**Lower Hill Redevelopment**  
First Amendment to Preliminary Land Development Plan

# Amendment to Section 1: Introduction & Section 2: Regulating Plans

Figure 2.25 Accessible Streets Diagram

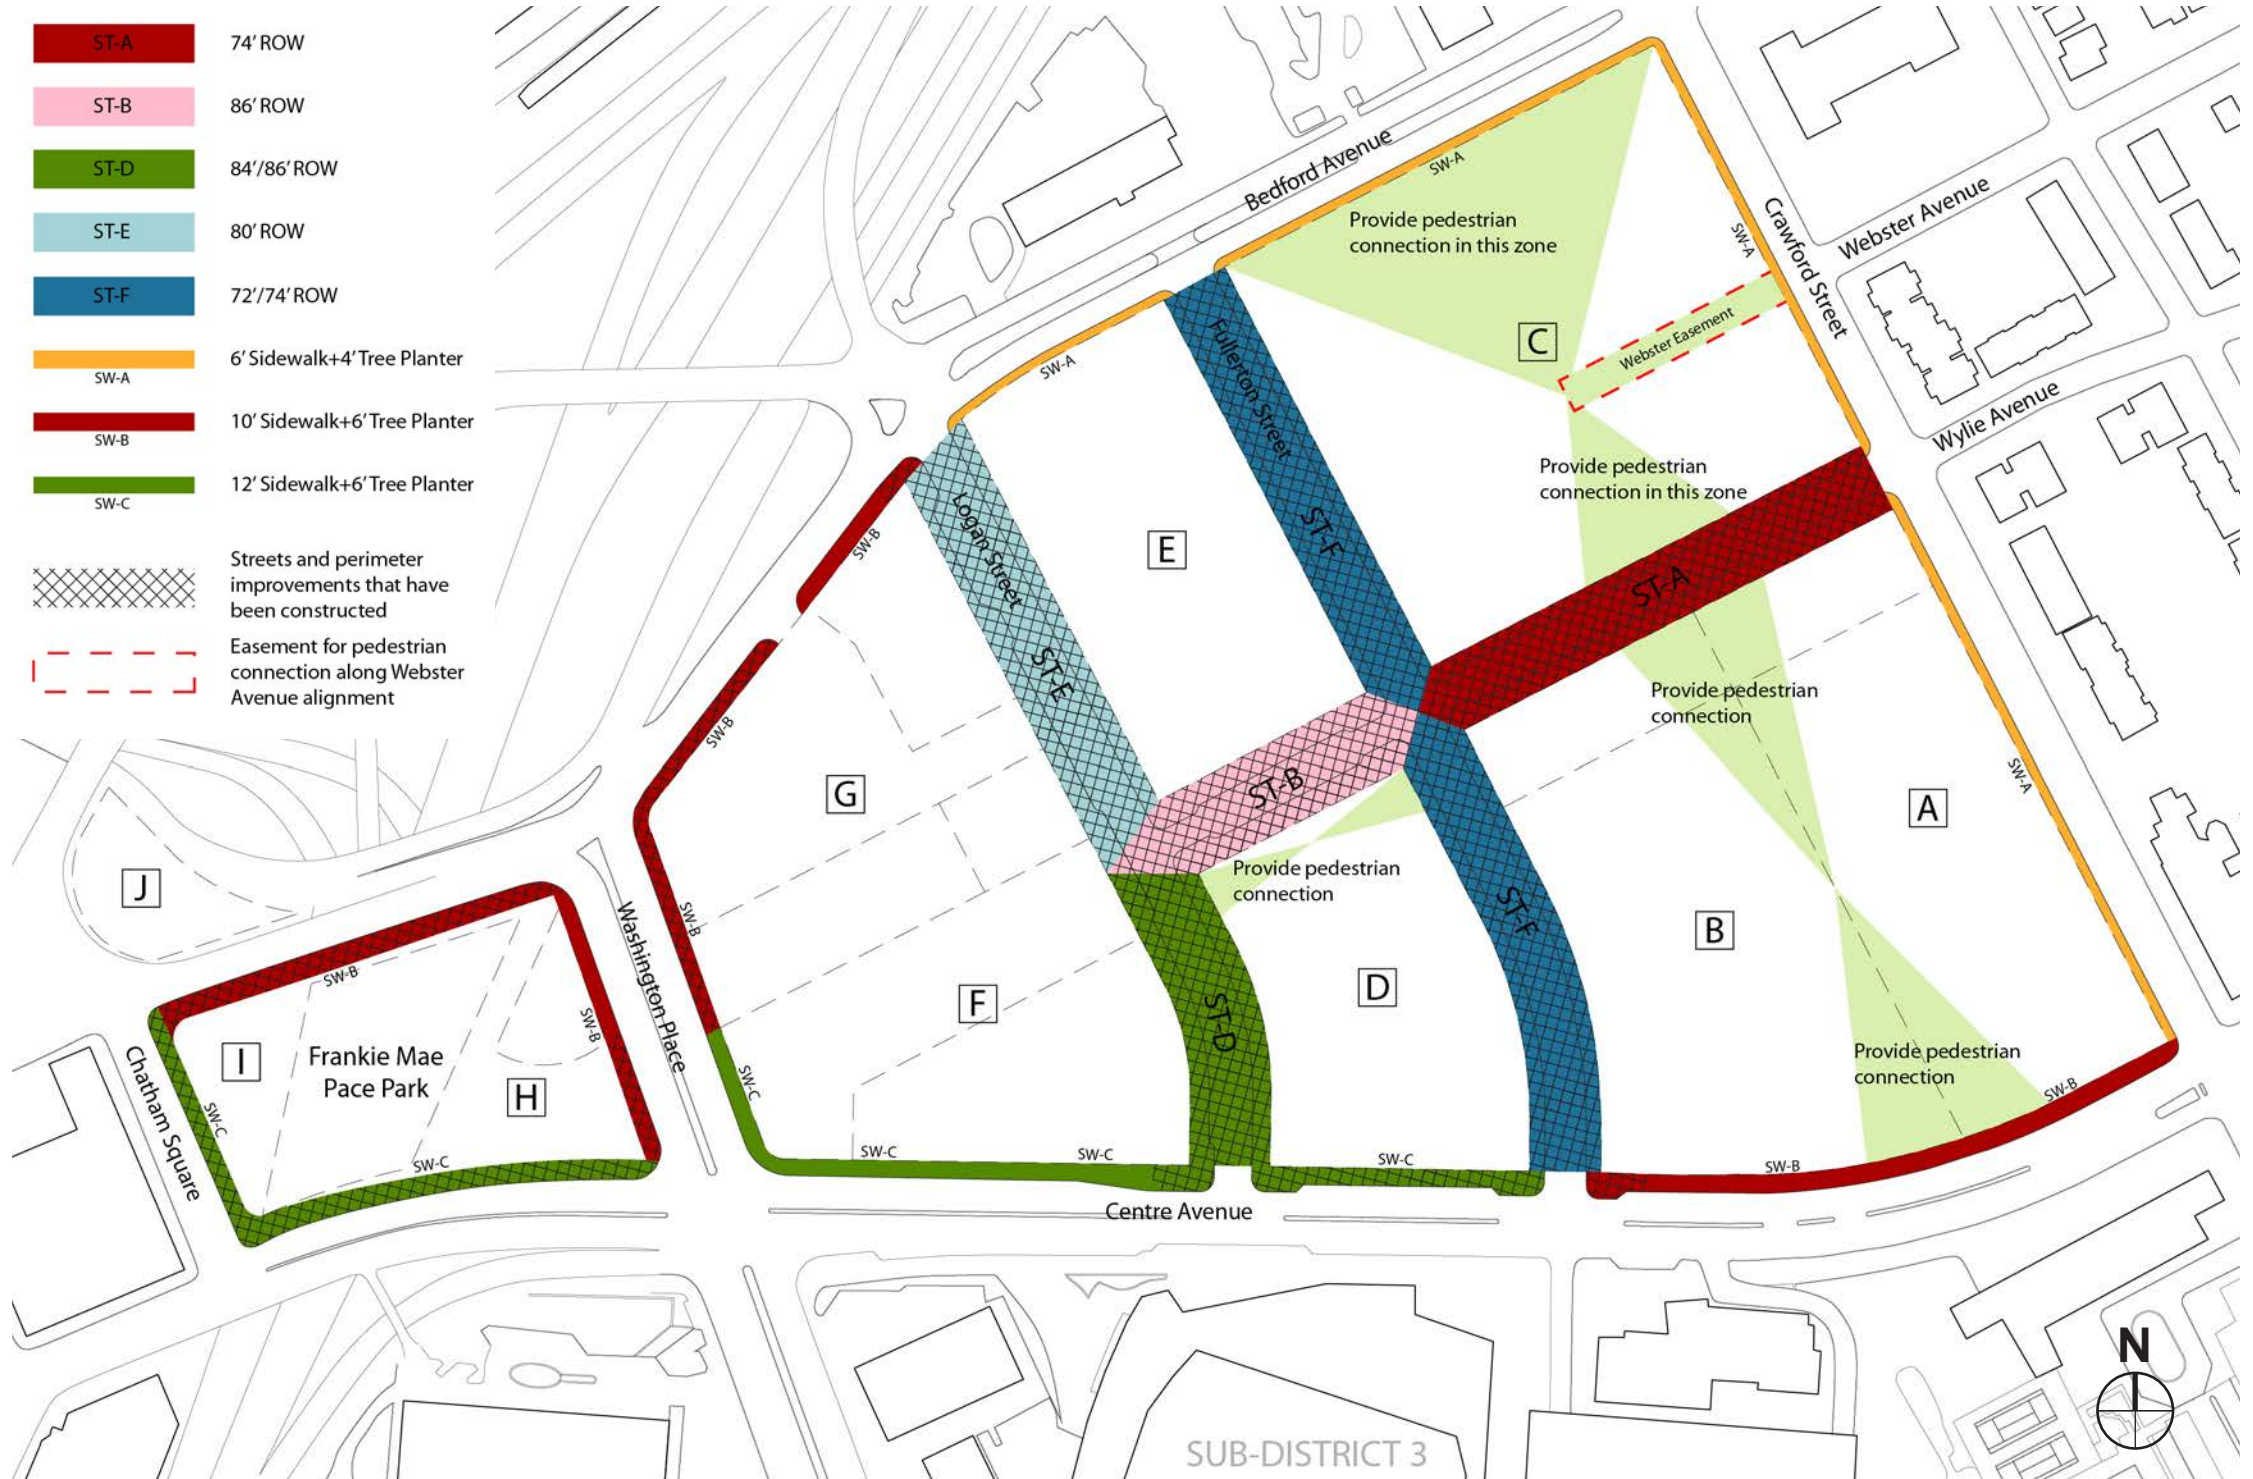
Figures 2.25 and 2.26 are revised to reflect the Block revisions identified in Section 2.4 and as follows:

Blocks A, B and C are modified, the required easement aligning with Webster Street is retained. Pedestrian connection zones are retained and modified in Blocks A, B and C. Pedestrian connection zones are added in Block D.

Figure 7.9.2 F2 urban open space development phasing diagram

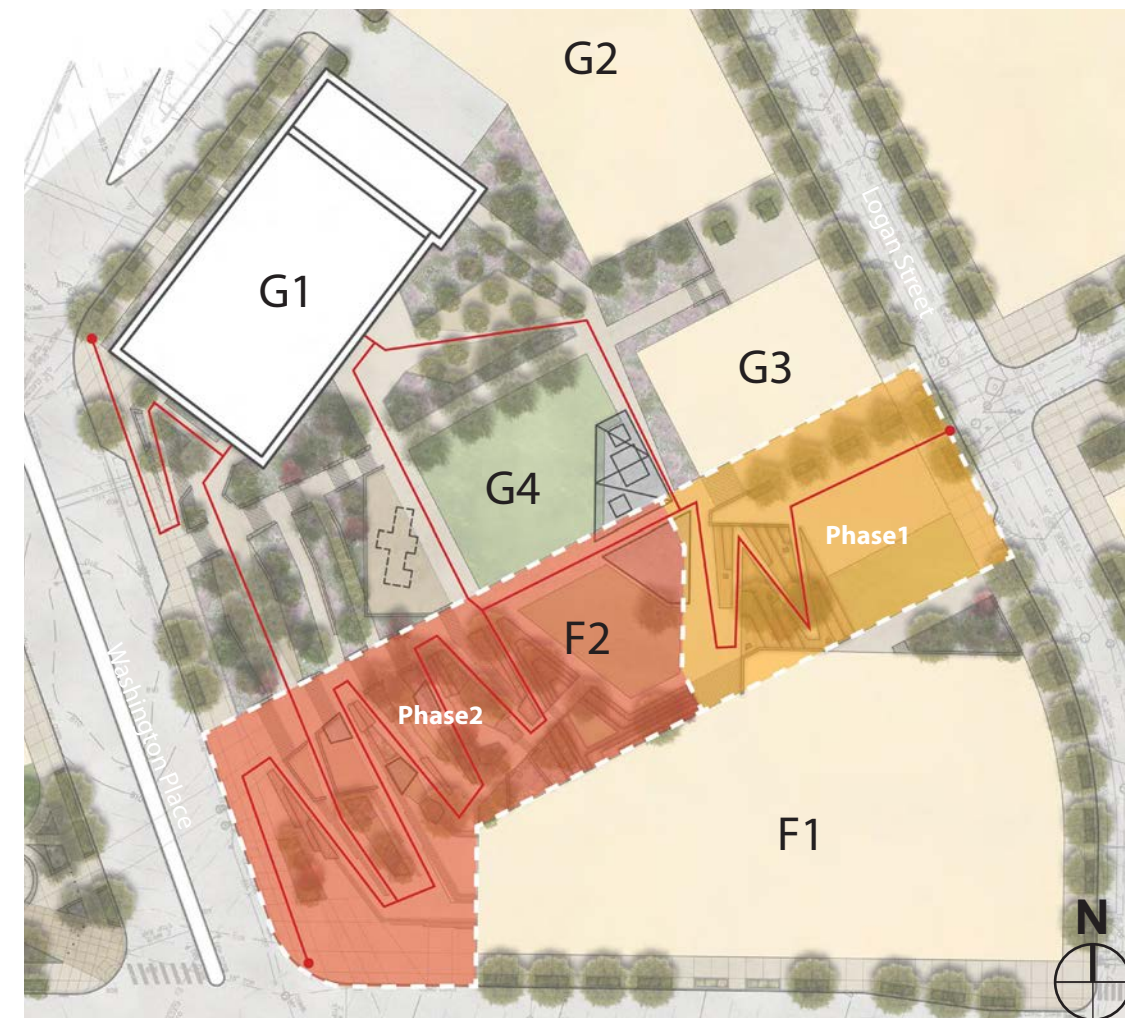
The planned Urban Open Space on Block F2 shall be commenced not later than May 4, 2023 which is two years following the approval of the FLDP for Block G1 and G4 which occurred on May 4, 2021. Block F2 Urban Open Space shall be improved in two phases. Phase 1, the upper section abutting Logan Street, shall provide for an accessible pathway from the G4 central lawn area to Logan Street, thereby extinguishing the temporary easement across G3. Phase 2, the lower section abutting Washington Place and Centre Avenue, shall be completed on or before the occupancy of the building on Block F1, thereby extinguishing the temporary easement through the G1 building. The completion of Phase 2 provides a permanent, accessible pathway from Washington Place at both the Bedford Avenue and Centre Avenue intersections to Logan Street and in the reverse. Refer to Figure 7.9.2 which diagrams the phasing and accessible pathways.

Figure 2.30 Street Frontages Regulating Plan

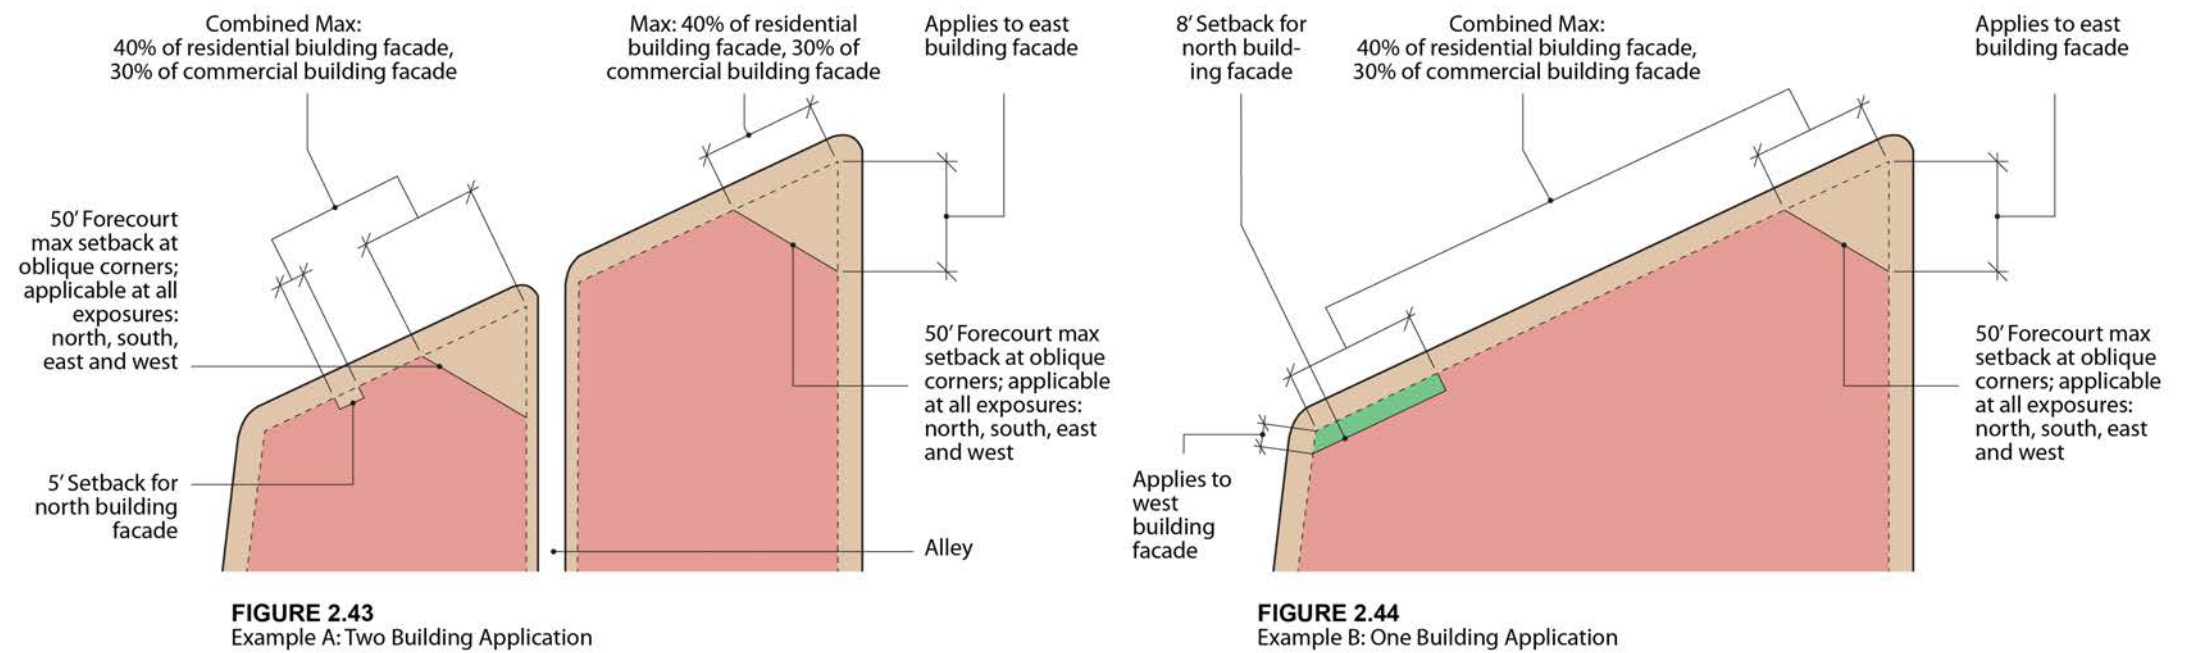
Figure 2.30 is revised to reflect the Block revisions identified in Section 2.4 and as follows: (1) Frontage Types B,C,D,E and F are permissible abutting Block A2 and B2 Urban Open Space, (2) Frontage types A,B,C,D are permissible along the parcel line of Block A1 and B2 in anticipation of an Alley, (3) Frontage types E and F are permissible abutting Block G4 and F2 Urban Open Space.

Figure 2.59 Minimum height requirement diagram

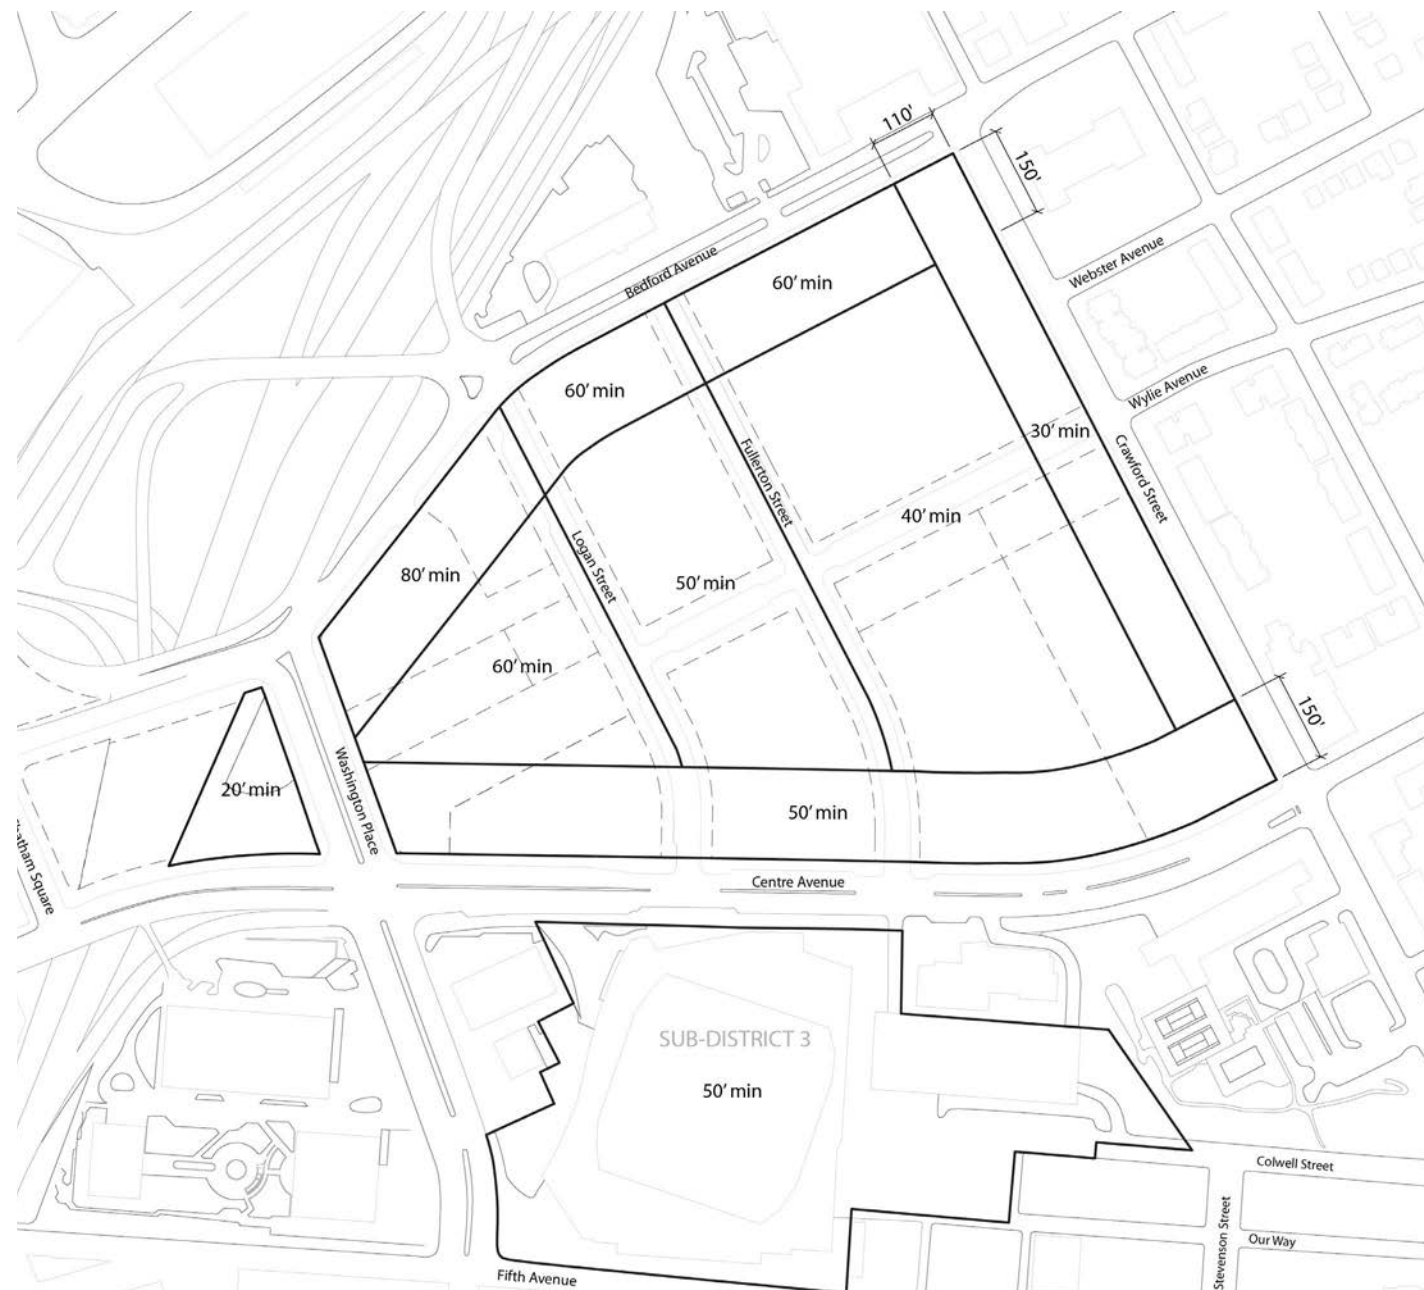
Figures 2.59 and 2.60 are revised to reflect the Block revisions identified in Section 2.4. Height Zones b, d, h, i and l are revised to correct discrepancies, these shall follow the criteria established in the SP-11 Lower Hill, Section 909.01.R.5(c), Height Standards.
